# SUNNICA ENERGY FARM DCO EXAMINATION

## WRITTEN REPRESENTATION

ANNEX F – CARBON

# Findings on the Proposed Sunnica Energy (Solar PV) Farm

**Fig 4 Comparison of Scheme’s GHG Emissions and GHG Offset throughout lifetime (for an unknown field size and unknown battery capacity) based on Sunnica’s given values (see Appendix H)**

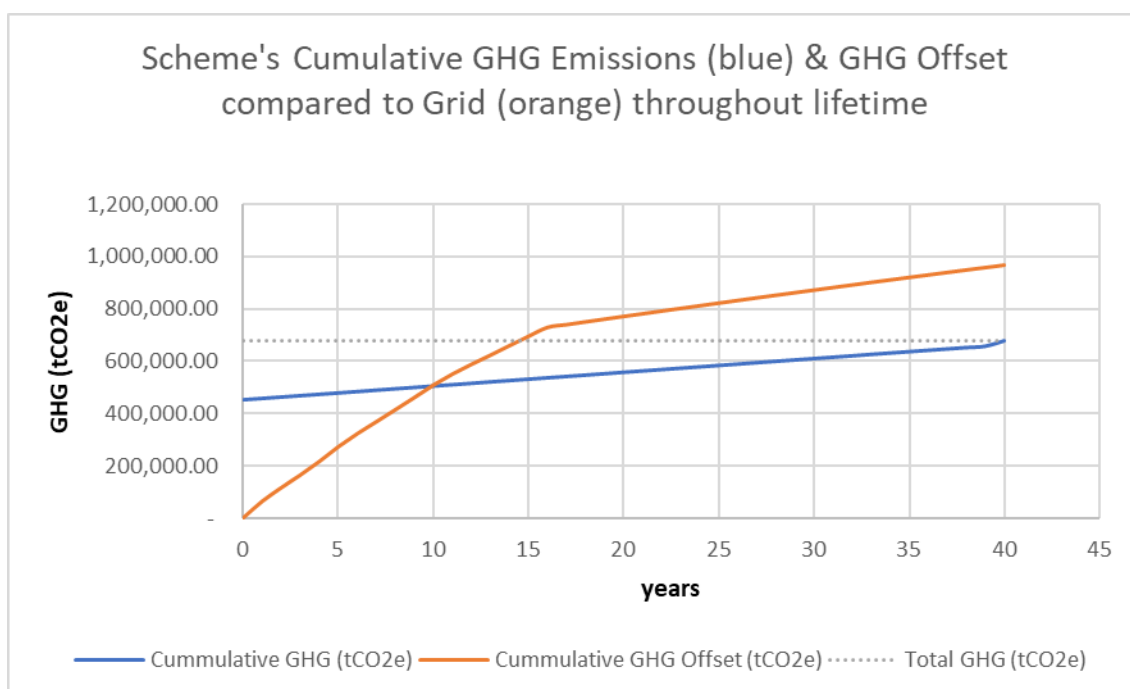
- 6.2.6 This plot based on Sunnica claims shows that emissions and offset overlap, seeking to demonstrate that the scheme is a “net-offsetter”. At 10 years there is a complete offset between the construction emissions and the annualised operation emissions. An overlap of the GHG offset line and the Total GHG line (in this case at about 15 years) signifies net-zero is achieved over the lifespan of the scheme. However, we will go on to show that based on our assessment of the GHG emissions (using Sunnica’s figures and making lenient assumptions for the batteries, transformers and cables where there is no available data), the plot is less optimistic than this.

6.2.7 It should be pointed out that the unusual “kink” in the orange offset curve at 17 years is due to the fact that, although we know that Sunnica compare the Scheme against the National Grid’s operational GHG performance, we have no information on what scenario is being used [12] but we are told that the projected grid intensity is not projected to fall lower than an operational figure of 27 gCO<sub>2</sub>e/kWh (ES section 6.8.24 p9-28) and reference is made to the Dept of Business, Energy and Industrial Strategy (BEIS) data tables 1 to 19, dated 2019 [2]. So, we have used the (BEIS, 2019) values but have “bottomed-out” at 27 gCO<sub>2</sub>e/kWh (see spreadsheet presented in Appendix H, column 4).

Fig 5. Comparison of Scheme’s GHG Emissions and GHG Offset throughout lifetime (for a 500MWp field with 500MWh battery storage).

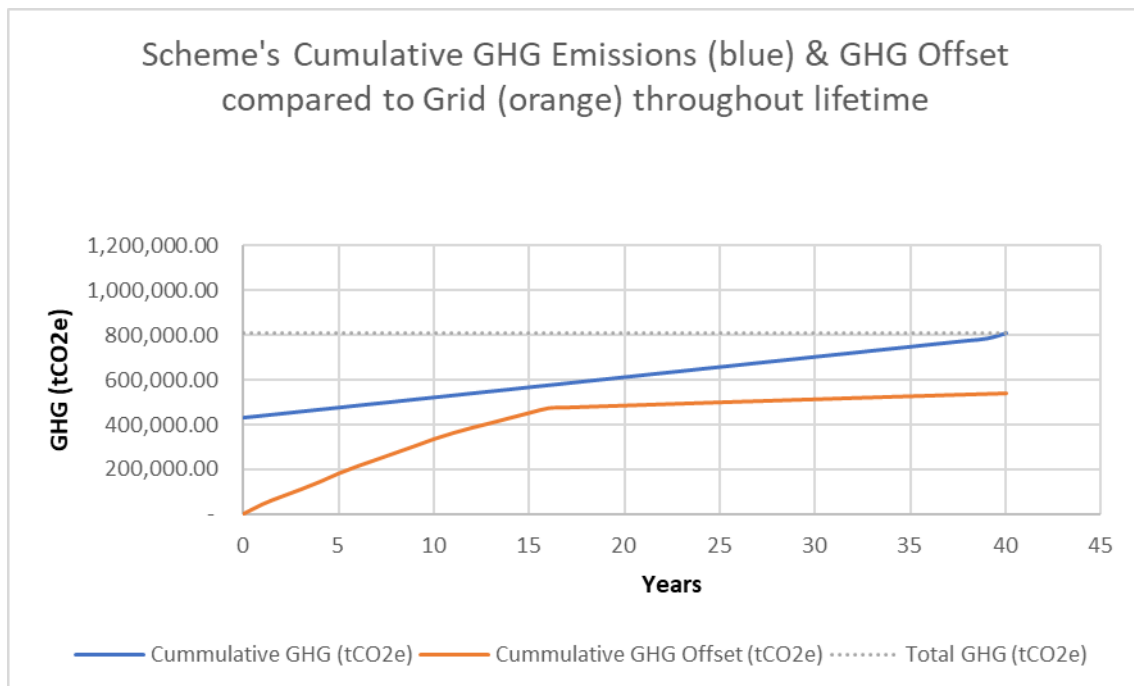
6.2.9 The key point to note here is that the lines for emissions and offset **do not** intersect nor do the offset and Total GHG. ***This means that, contrary to the claim by Sunnica, the Scheme cannot reach net-zero carbon emissions within its lifetime and is in fact a net-emitter of CO<sub>2</sub>.*** It should be stressed again, that we have achieved the plot in Fig 5, using Sunnica’s figures except for “favourable” assumptions that we’ve had to make regarding batteries/transformers and cables, where no data was provided at the time.

Photo B2: highlighting Section 1.1.1 of the SEF EIA Scoping Report dated March 2019

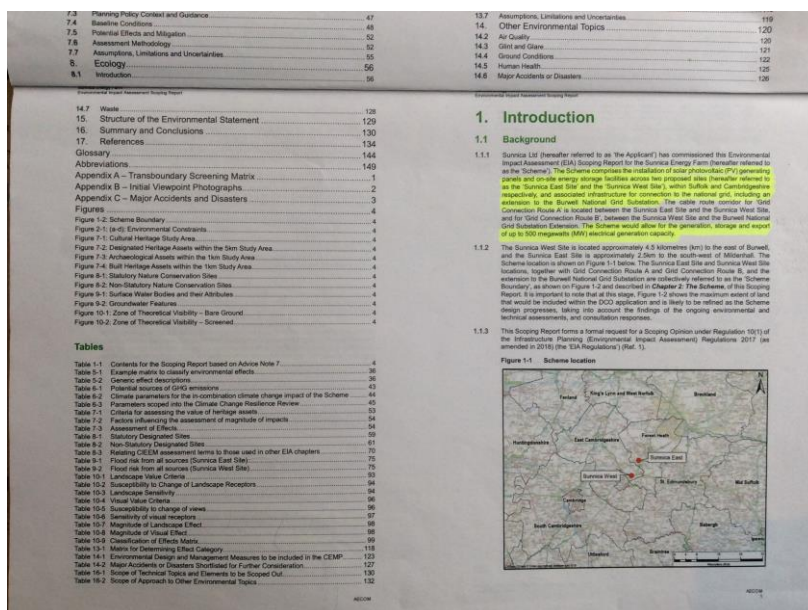
The following photos show the front cover of the SEF EIA Scoping Report dated March 2019 (Photo B1) and its associated p1, detailing section 1.1.1 (Photo B2). The last sentence of the latter comments that “The Scheme would allow for the generation, storage and export of up to 500 megawatts (MW) electrical generation capacity”.
